Subject: Duane Arnold Energy Center  
Docket No: 50-331  
Op. License No: DPR-49  
Response to Request for Additional Information (RAI) to Technical  
Specification Change Request TSCR-042 – Extended Power Uprate.  
(TAC # MB0543)

Attachment: DAEC Responses to NRC Human Factors Branch Second Request for  
Additional Information Regarding Proposed Amendment for Power  
Uprate

**DAEC Responses to NRC**  
**Human Factors Branch**  
**Second Request for Additional Information**  
**Regarding Proposed Amendment for Power Uprate**

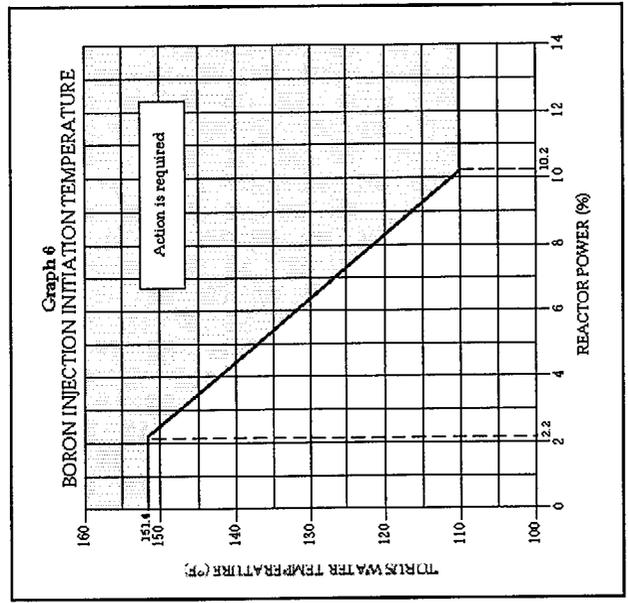
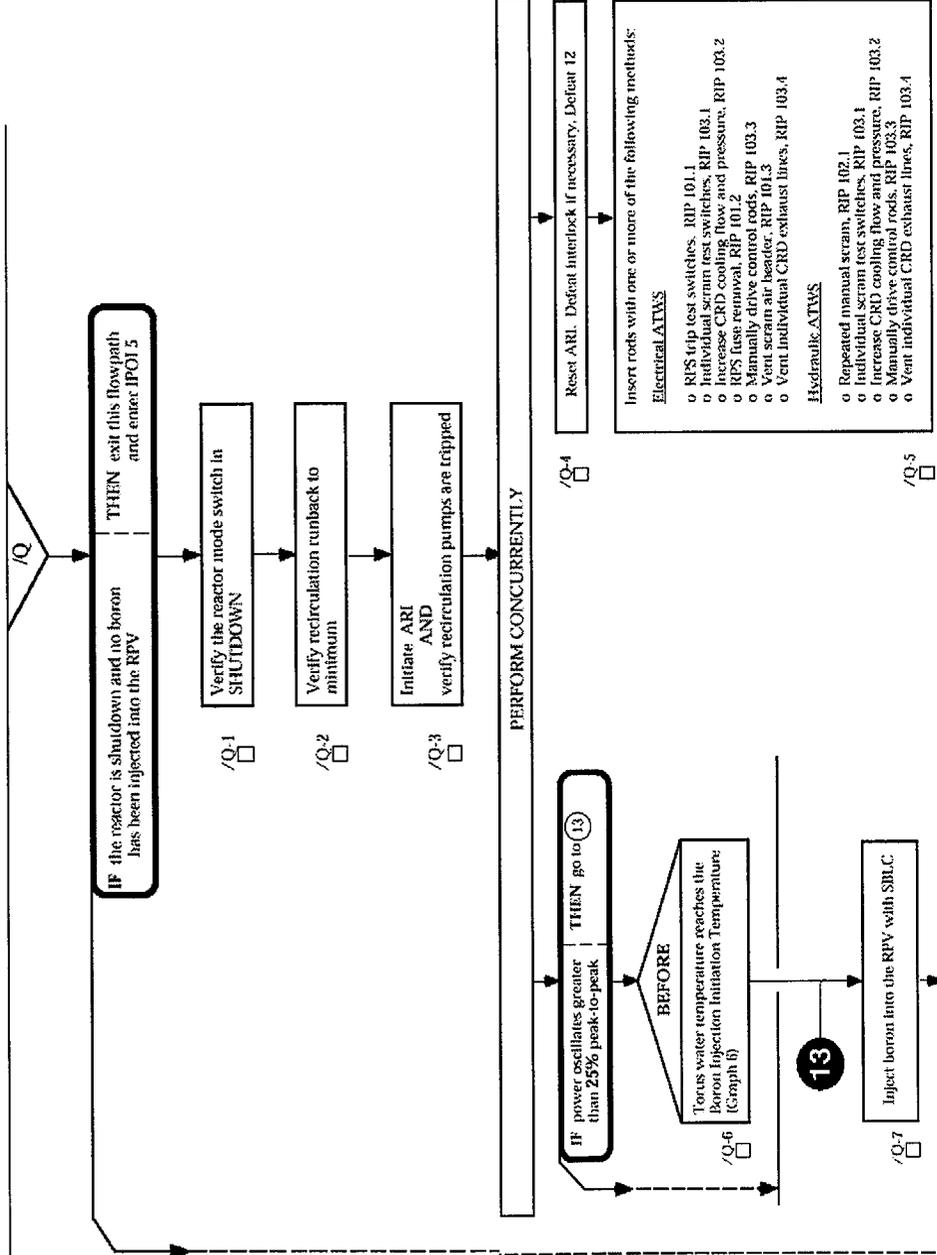
- a) In your May 10, 2001 Response to Request for Additional Information (i.e., NG-01-0637), you described the change in Human Error Probability for Operator actions associated with Standby Liquid Control System (SLCS) injection during an Anticipated Transient Without Scram (ATWS) event, as modeled in your Probabilistic Risk Assessment (PRA) for Extended Power Uprate (EPU). Of particular concern is the reduction in available Operator time for “early” SLCS injection from 6 minutes presently to 4 minutes under EPU. With respect to that decreased Operator response time, please provide further justification that this assumption is consistent with actual Operator response time. Specifically, please provide the following additional details:

- (i) Provide additional detail regarding the actual Operator performance steps to diagnose the need for SLCS injection and the execution of that action, including a discussion of the controls on the use of the mode switch key used to initiate SLCS.

- (i) Attached is the relevant portion of the ATWS Emergency Operating Procedure (EOP) dealing with SLCS injection, i.e., Power Control (/Q). After entering this EOP, the Operator takes several immediate actions, such as placing the Mode Switch in “Shutdown,” ensuring the reactor recirculation pumps are at minimum pump speed, and initiating the Alternate Rod Insertion (ARI) and ATWS-Recirculation Pump Trip (ATWS-RPT) system, prior to reaching the steps dealing with SLCS injection. At this point in the scenario, after determining that a thermal-hydraulic instability does not exist, there is only one key parameter of interest, suppression pool (torus) temperature (See the BEFORE step (/Q-6) in the attached EOP.) Consequently, a Reactor Operator at the control panels, the Shift Supervisor and the Shift Manager are all monitoring the suppression pool temperature on the control room instrumentation. In addition, the suppression pool temperature is monitored on the Safety Parameter Display System (SPDS); in particular, the SPDS is automatically trending the temperature directly on the Boron Injection Initiation Temperature (BIIT) curve, the EOP criteria for SLCS injection. This display is monitored by both the Shift Technical Advisor (STA) and the Shift Manager, in addition to being plotted manually on the BIIT curve on the EOP chart. Therefore, it is highly unlikely for the suppression pool temperature to increase beyond the BIIT curve limit undetected by the Operators.

Given this recognition that SLCS injection is required, per the ATWS-EOP step (/Q-7) to “Inject boron into the RPV using SLCS,” execution of this task is very simple – only 3 steps. Using three-part communication between the Reactor Operator and the Shift Supervisor which reduces the potential for miscommunication, upon direction from the Shift Supervisor to initiate SLCS, the Reactor Operator 1) removes the key from the Reactor Mode Switch; 2) places it in the handle of the SLCS pump control switch and unlocks it; and then, 3) turns the SLCS pump control switch (a simple, two-position switch) from “Off” to the “PUMPS A and B Run” position. The two switches are located on the same control room panel and are within a couple of feet of each other. Hence, the Operator does not have to change physical location to perform this action.

At this point the Reactor Operator has completed the task of SLCS injection. The Operator then verifies that SLCS has successfully actuated by observing the indication lights (pump running indication lights and the squib injection valve indication lights) and pump flow and discharge pressure indications, which are on the same panel. In addition, there is an Annunciator alarm associated with the firing of the squib valves. The Operator then reports back to the Shift Supervisor, again using three-part communication, that SLCS injection has been successfully initiated. The Shift Supervisor then records the action as completed on the EOP flowchart (step /Q-8).
